27 April 2018

SSD 8574 Waitara Public School Redevelopment Application - objection

Attachment 2

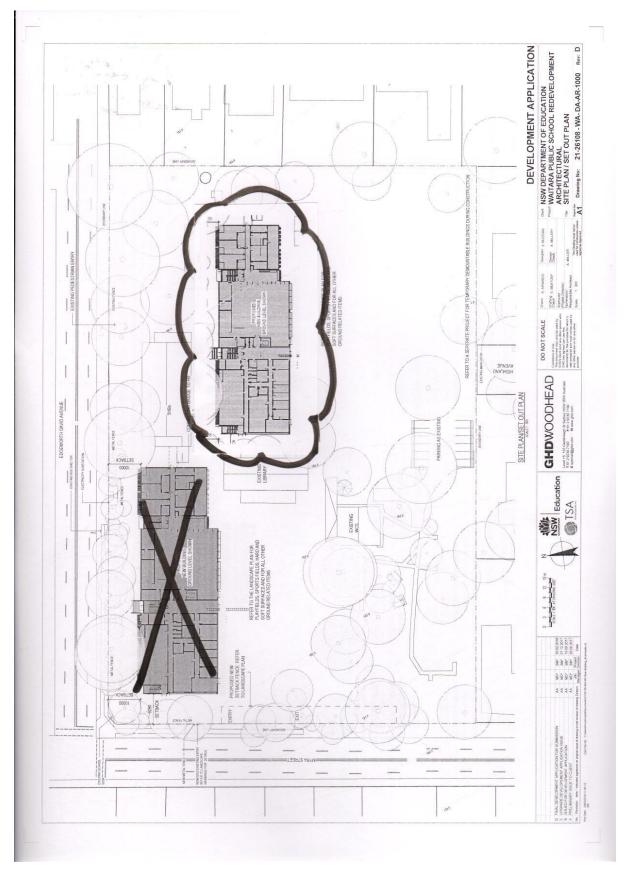
If the proposed building were repositioned to the eastern part of the site and somewhat further south of Edgeworth David Avenue (see Attachment 2), i.e. further within the site, but still at the same approximate height, this would allow for:

- Improved screening of the building from both the two subject street frontages and accordingly, less visual impact on the public domain;
- The retention of the same number of the site's trees or even possibly a slightly increased number; and
- The retention of the required maximisation of the school site's open space opportunities.
